# Future Direction and Recap

# Breakaway Oxidation

**Figure 2**

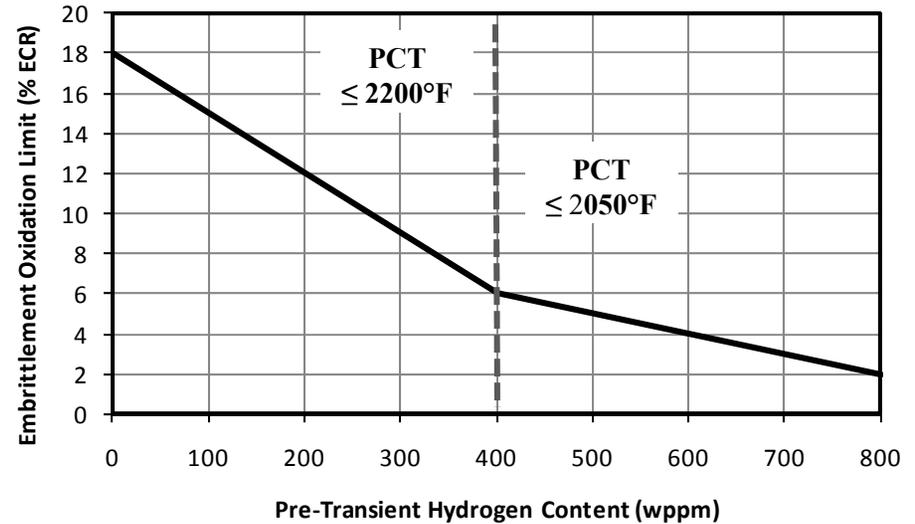
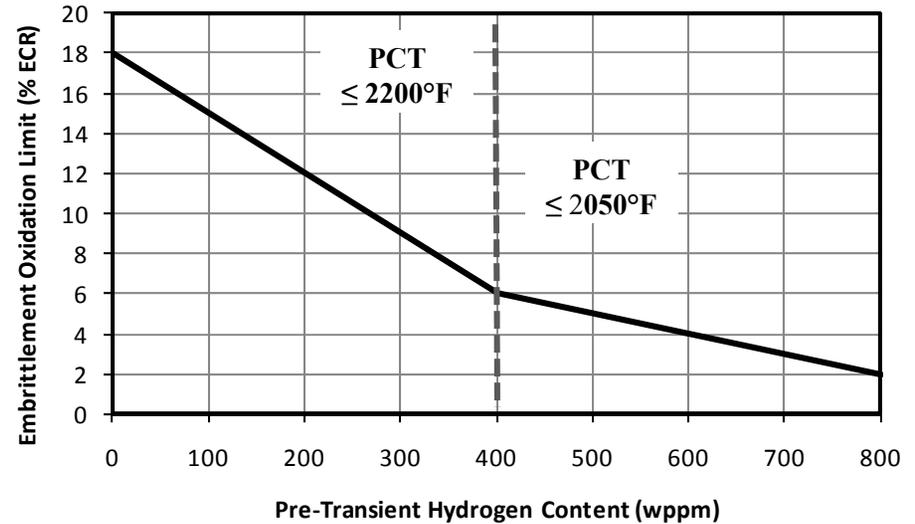
NRC is considering:

New alloy's that (1) use the same reduction method, (2) operate less than or equal to the maximum fluence, (3) include only the alloying elements present in the materials tested and (4) have similar alloying content of each element to the materials tested, then a reduced level of testing could be considered to adopt figure 2.

- As-received (AR) material
- Reduce pre-hydrided testing to only 2 [H] levels
- Eliminate testing of irradiated material

Default definition of “similar” as 10% deviation from alloying limits defined for tested alloy

Alternative definitions of “similar” can be proposed and reviewed

Alternatives proposed in comments and during discussion:

- Alloys that fall in the above range can use Figure 2 without testing
- Total alloying content <2.2% can use Figure 2 without testing
- Testing of an alloy used to develop Figure 2 in combination of a new alloy, showing similar behavior to the tested alloy, should be acceptable to adopt Figure 2.

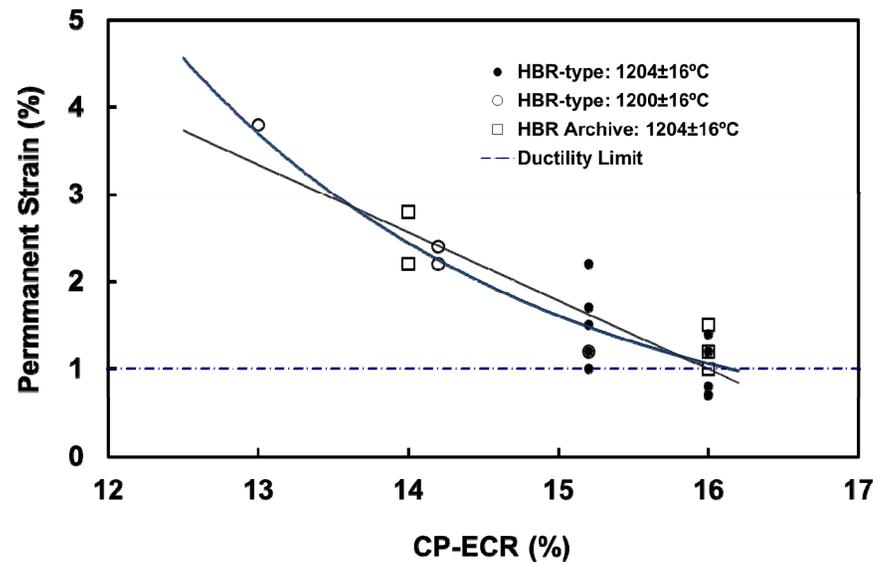
# Breakaway Oxidation

Discussion of default frequency and sampling population:

- Regulatory Guidance: Testing once per ingot (three repeat tests at the conditions defined by analytical limit), testing final cladding at the end of cladding manufacturing, accounting for factors that may influence behavior between manufacturing and loading in the reactor (for example, surface effects)
- Vendor activities: Testing of ingots for chemical effects, justification of change control processes to address implications of manufacturing processes on breakaway oxidation behavior.
- Alternative proposals:
  - Single pass/fail test, no repeat testing for periodic testing
  - Minimal requirement to qualify a process, require confirmation when process changes.
    - Challenge: how to define a “process”
  - Use value higher than 650C in the application of the breakaway oxidation analytical limit

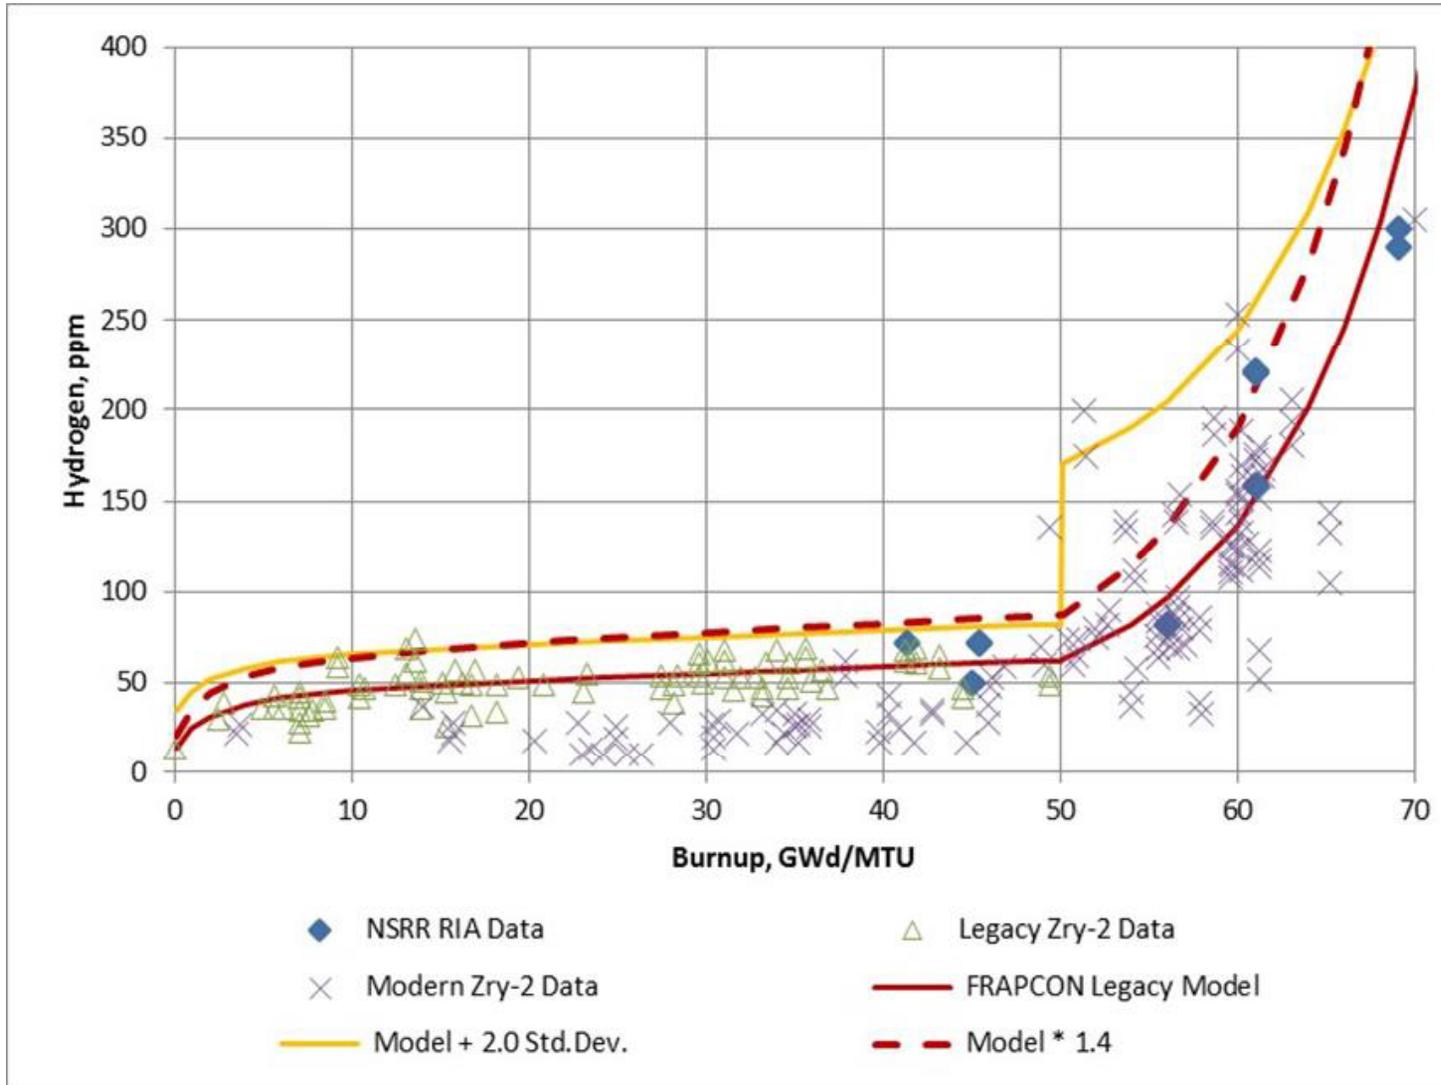
# DBT from RCT

- If all RCT results from a single oxidation sample are ductile, declare that oxidation level ductile
- If all RCT results from a single oxidation sample are brittle, declare that oxidation level brittle

- If the RCT results from a single oxidation sample include both ductile and brittle results declare that oxidation level transitional
- Alternatively, a proposal for conditions where “brittle” results can be averaged with ductile RCT results from a single oxidation and quench sample. Offset strain values greater than or equal to 2% can be averaged with other ductile results. Permanent strain values greater than or equal to 0.8% can be averaged with other ductile results.

- Values of [H] for each ring should be measured following RCT and noted in the table
- The DBT could be determined as the CP-ECR, rounded to the nearest 0.1%, from interpolation between an oxidation level for which the RCT results were ductile and an oxidation level for which the RCT results were brittle and the CP-ECR values differ by no more than 2.0%.

- Alternatively, the DBT could be determined as the CP-ECR, rounded to the nearest 0.1%, from interpolation between an oxidation level for which the RCT results were ductile and an oxidation level for which the RCT results were transitional and the CP-ECR values differ by no more than 1.0%.

- The number of repeat tests needed would be correlated with observed data scatter.
